PSC Box Beam and PSC Cored Slab Beam Bridges Common Item and Quantity Errors

Example 1 - PSC Box Beam Bridge

Example 2 PSC Cored Slab Beam Bridge

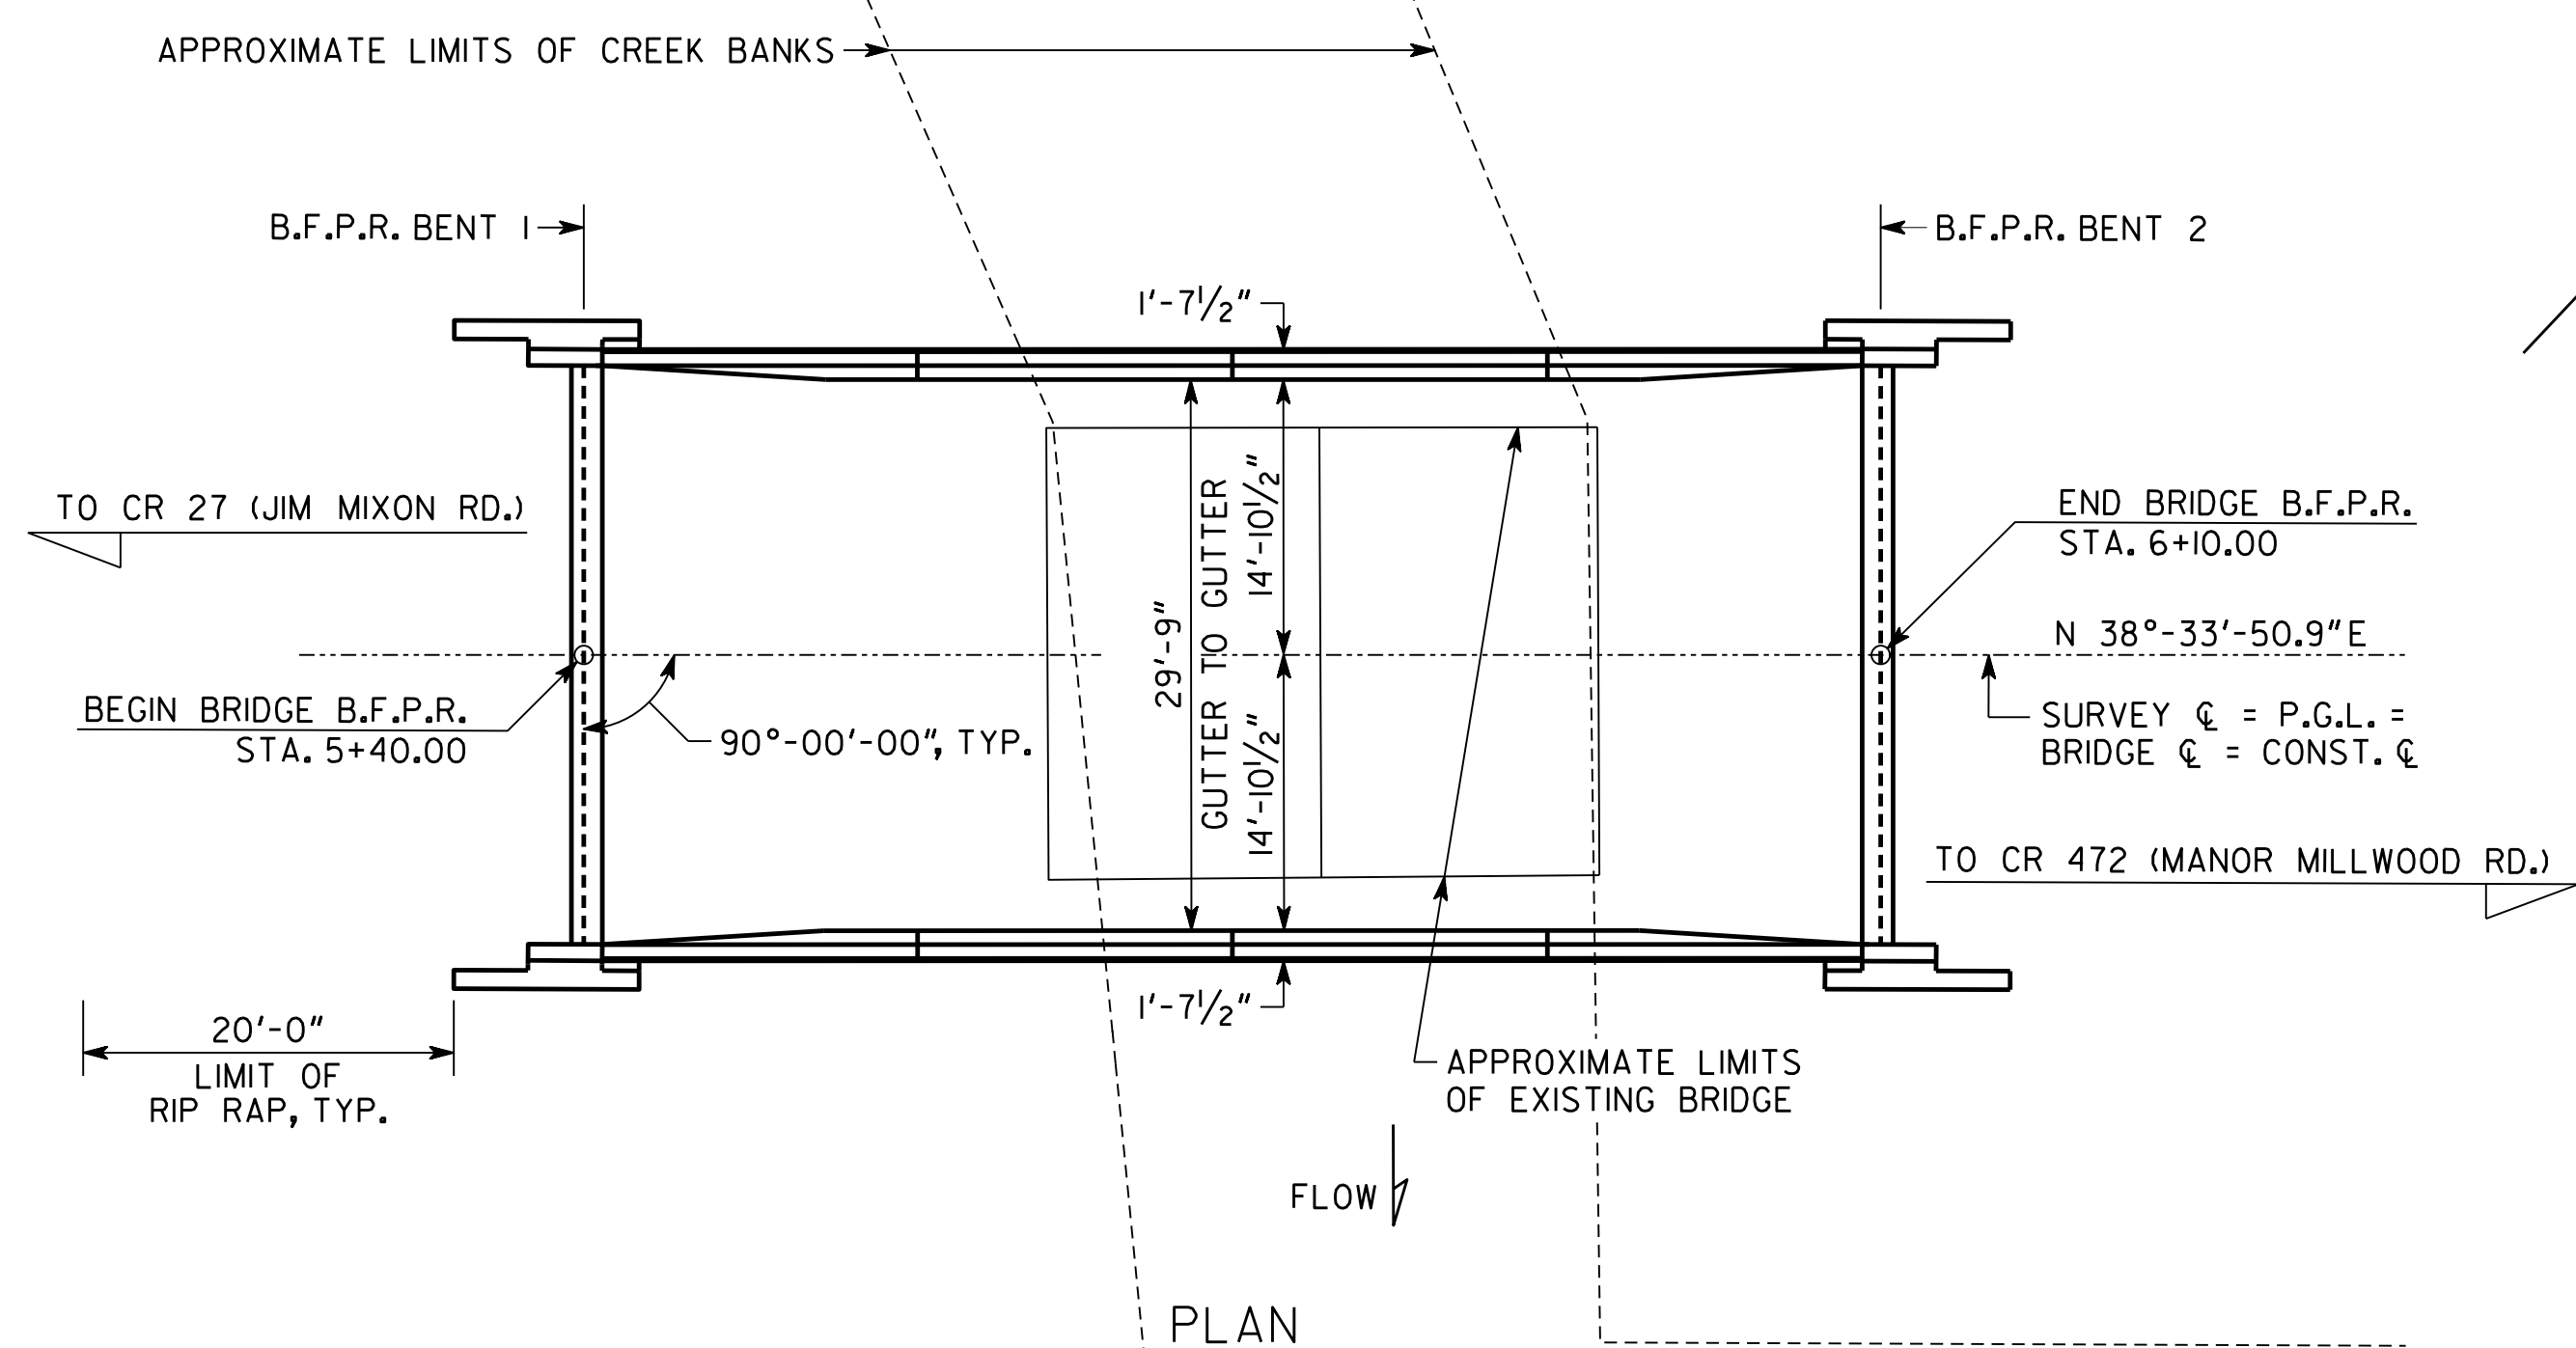
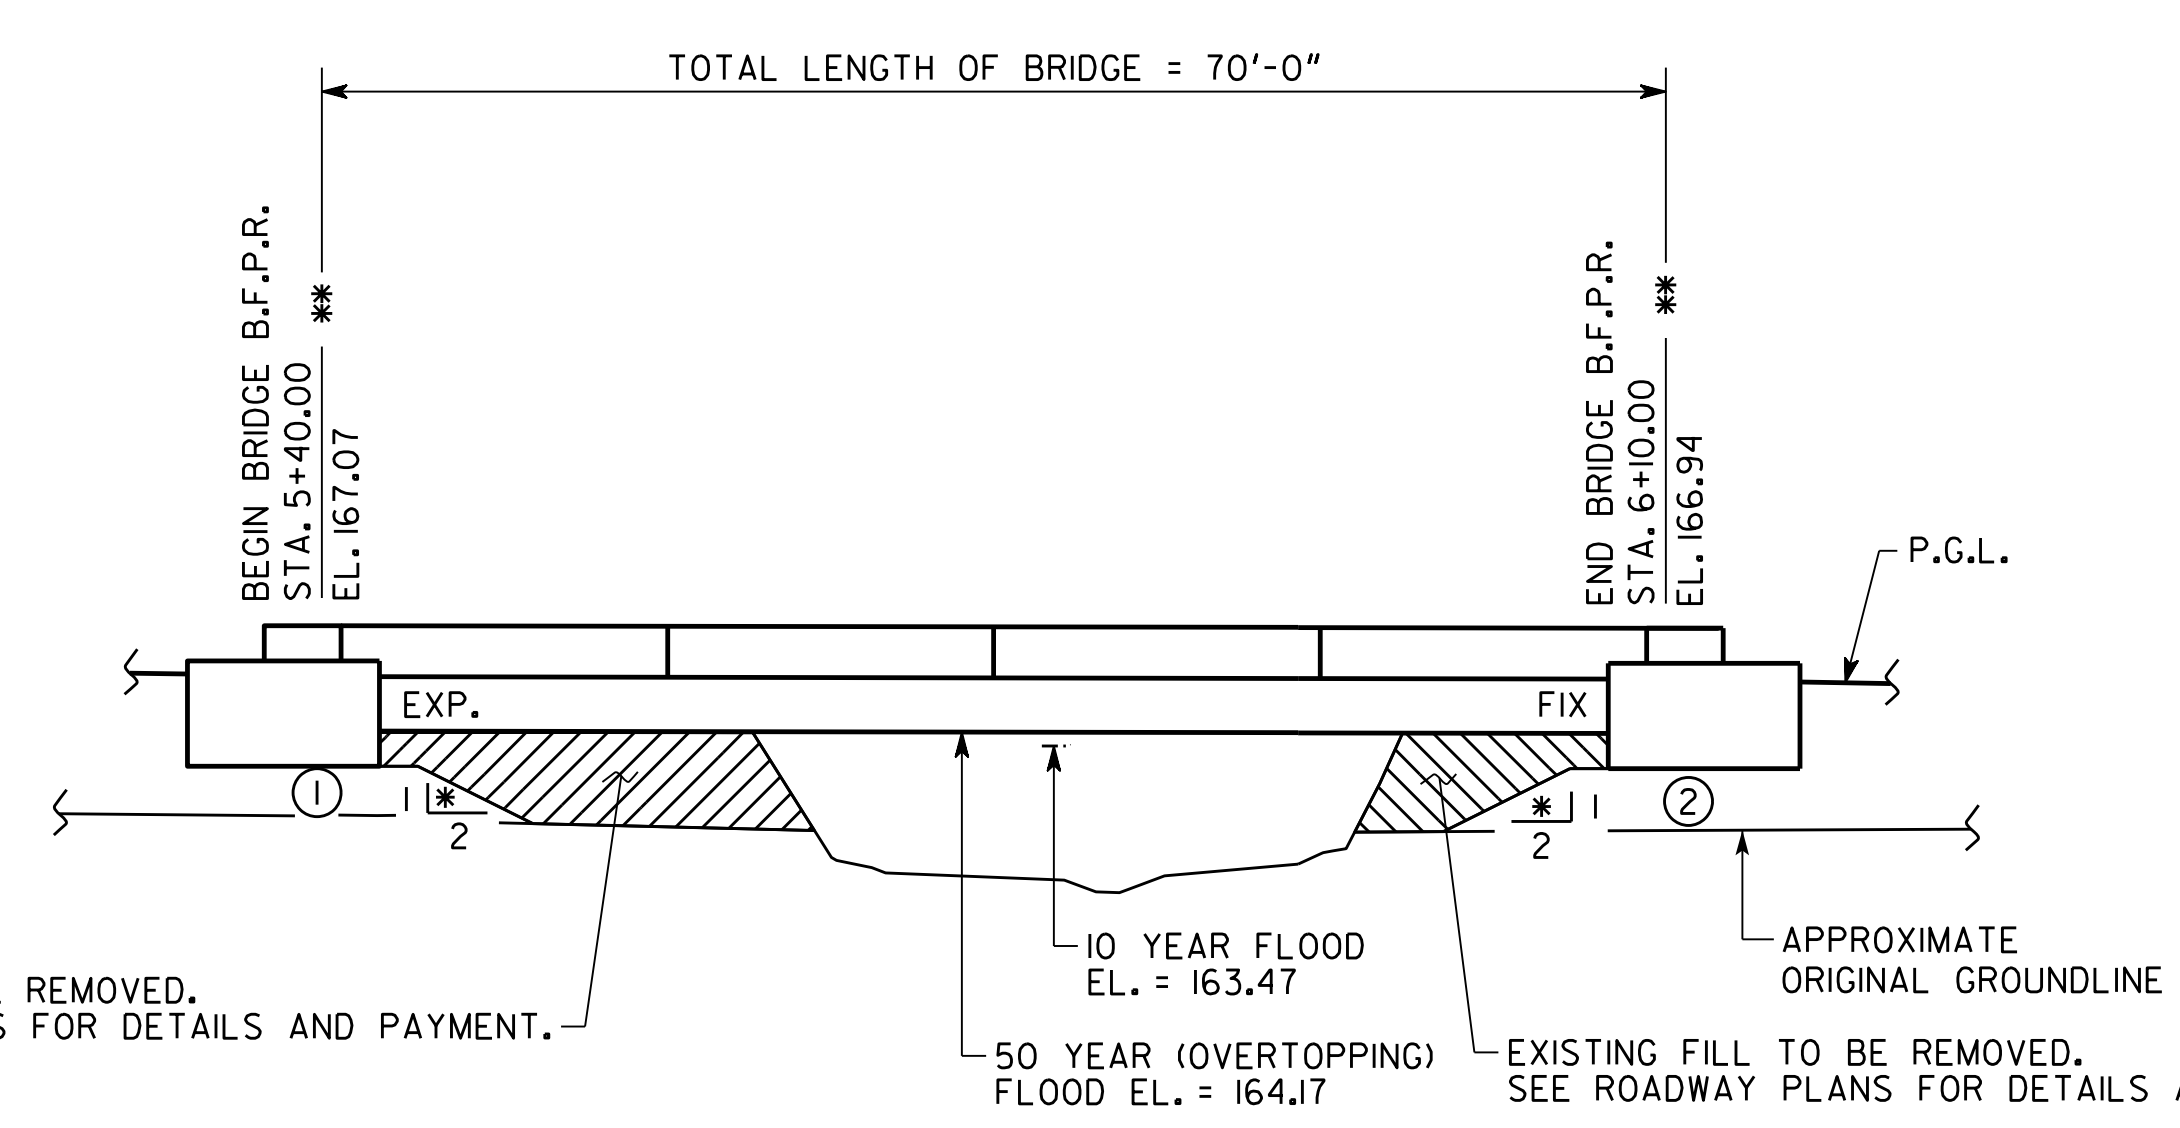
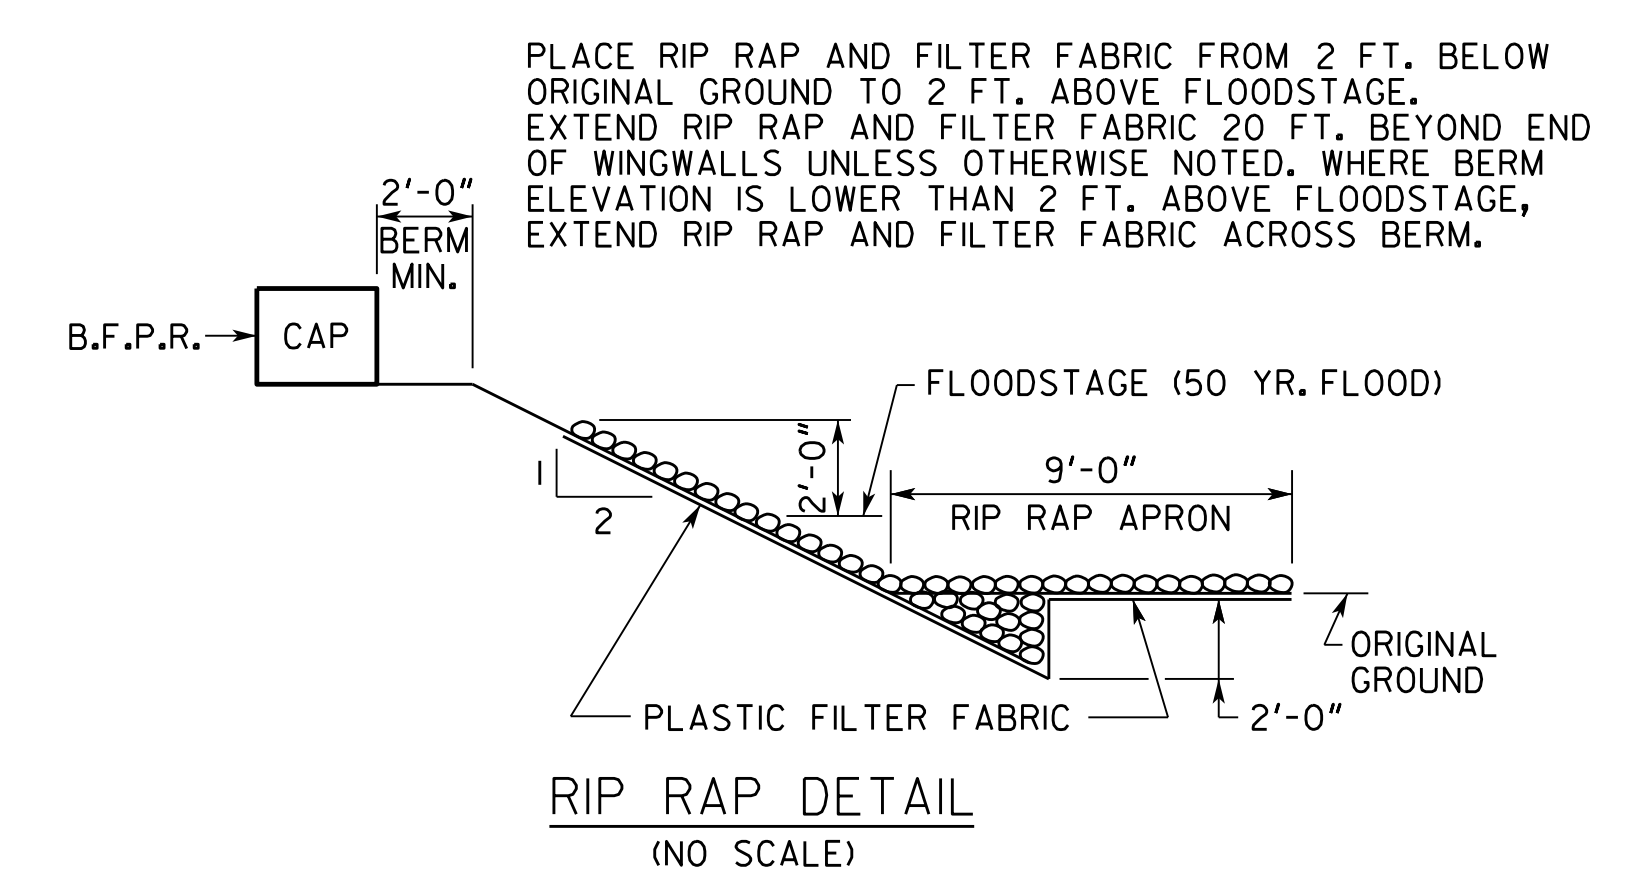
Bridge is on a tangent alignment

DRAWING NO. 35-0002	DESIGNED <u>KRS</u>	CHECKED <u>KNT</u>	REVIEWED <u>DLC/SKG</u>
BRIDGE SHEET 2 OF 10	DRAWN <u>KRS</u>	DESIGN GROUP <u>EJC</u>	APPROVED <u>WMD</u>

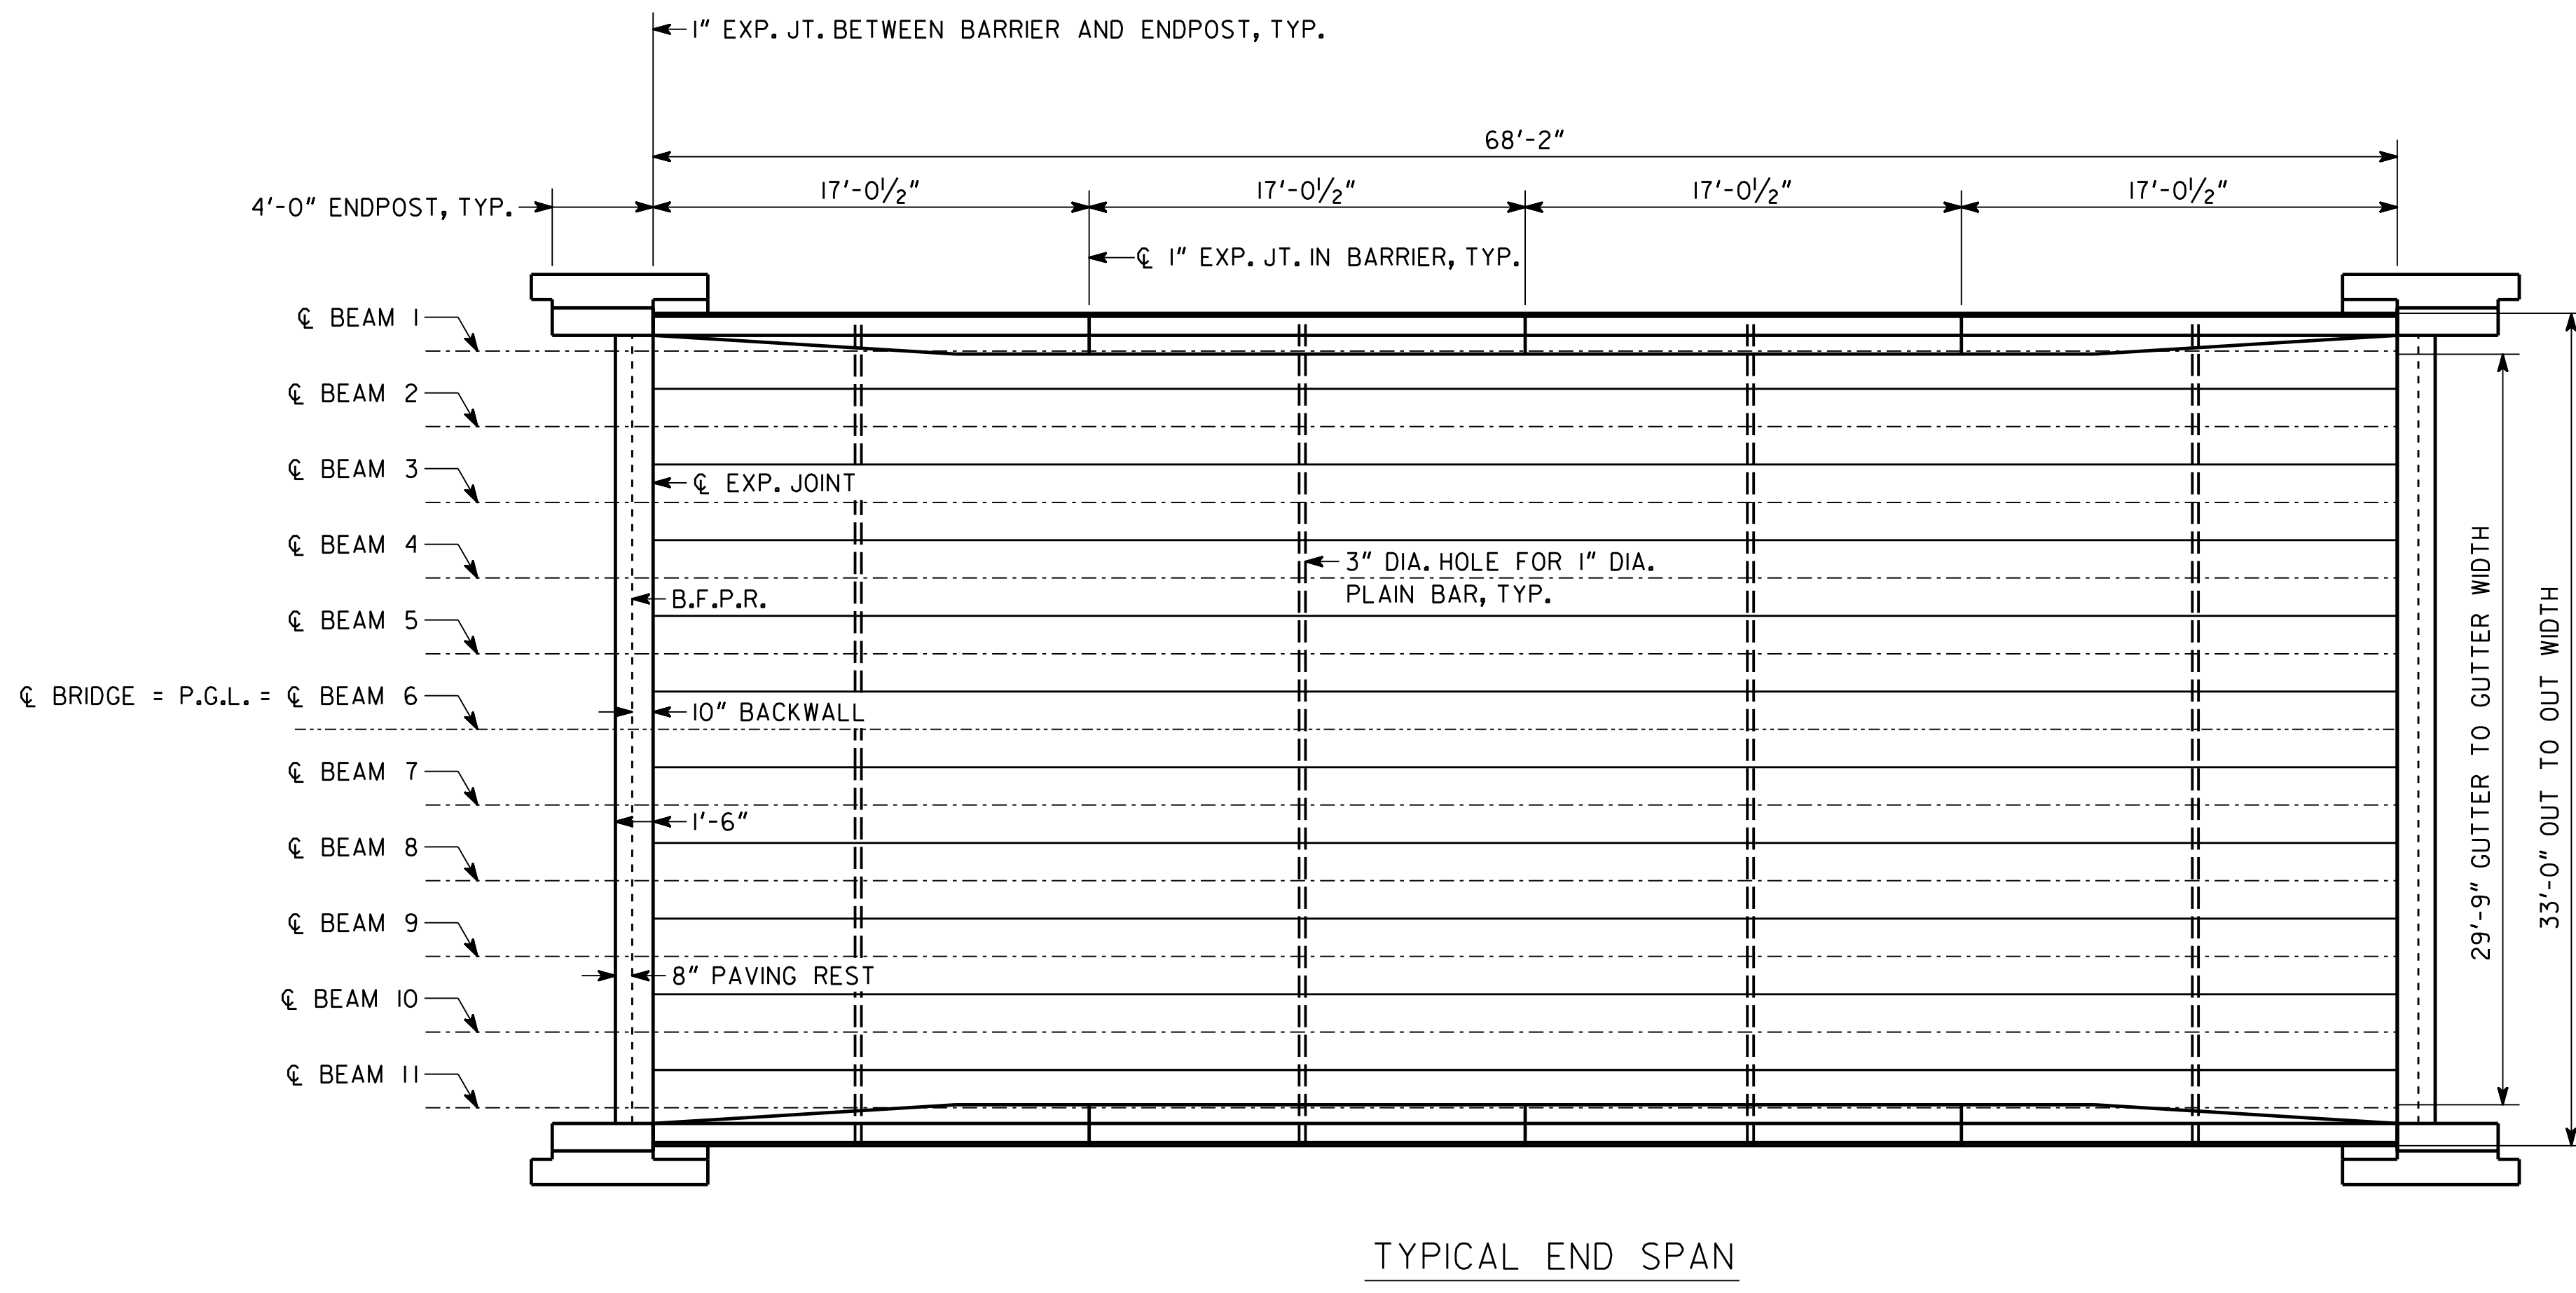
Bridge Quantities Do Not Include the Recycled Asphaltic Concrete or Tack Coat for the Leveling and Overlay of the Bridge Deck

BARRIER DRAIN DETAIL
SCALE: 3/4" = 1'-0"

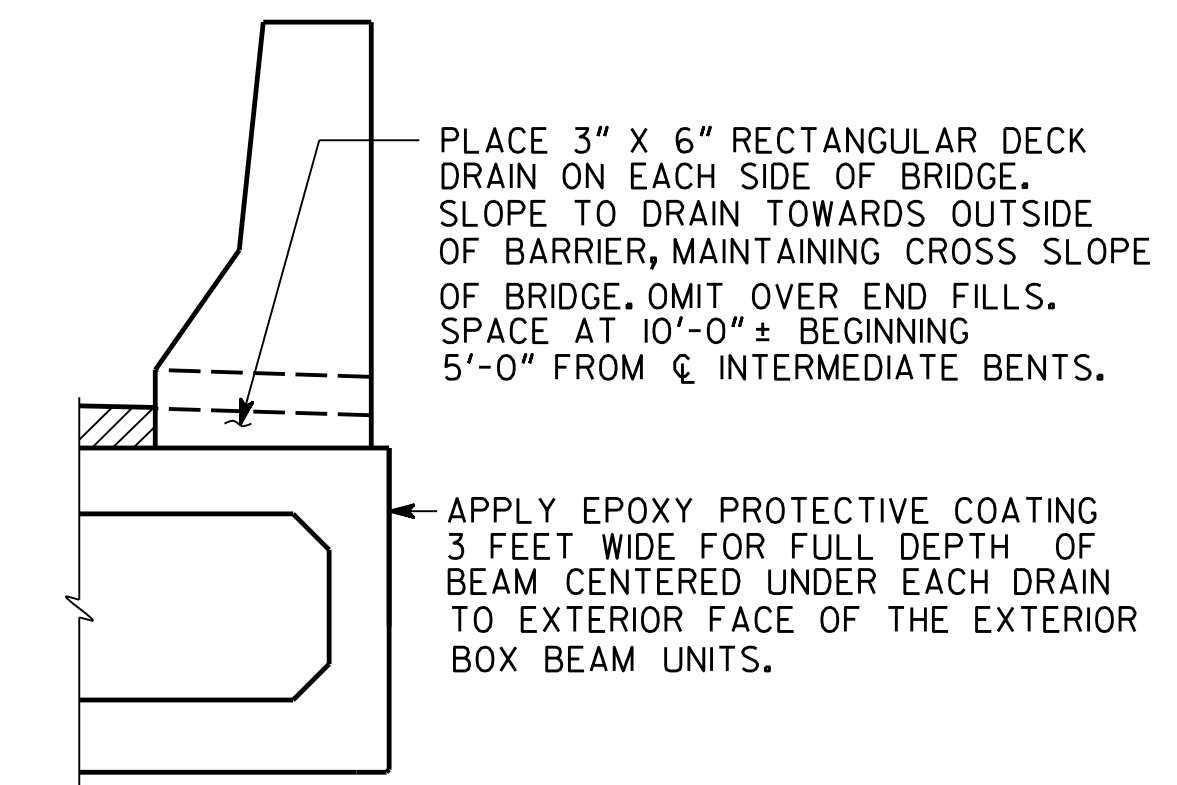
Minimum Overlay Thickness at Gutter Line/Face of Barrier
